HISTORIC AND DESIGN REVIEW COMMISSION

April 07, 2021

HDRC CASE NO: 2021-151
ADDRESS: 333 SADIE ST
LEGAL DESCRIPTION: NCB 729 BLK 3 LOT S 98.9 FT OF 9 ARB 9B
ZONING: R-6, H
CITY COUNCIL DIST.: 1
DISTRICT: Lavaca Historic District
APPLICANT: Shawna Walker
OWNER: GONZALES DANIEL
TYPE OF WORK: Amendment to previous HDRC approval
APPLICATION RECEIVED: March 25, 2021
60-DAY REVIEW: Not applicable due to City Council Emergency Orders
CASE MANAGER: Rachel Rettaliata

The applicant is requesting a Certificate of Appropriateness for approval to amend the previously approved garage door design.

333 Sadie – Sanborn Maps

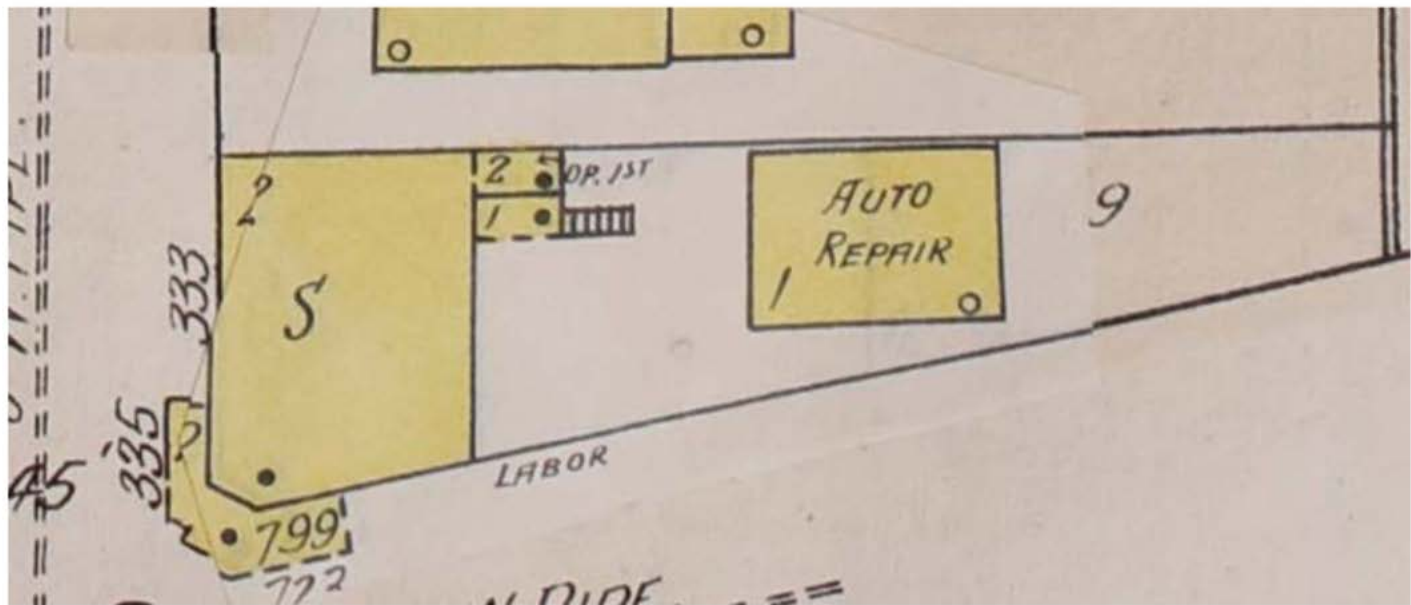
1931, v.3, p. 257 – separate building for auto repair at rear of main store.

1938, v.3, p. 257 – shows a separate dry cleaners' at the rear of main store. Unclear whether auto repair
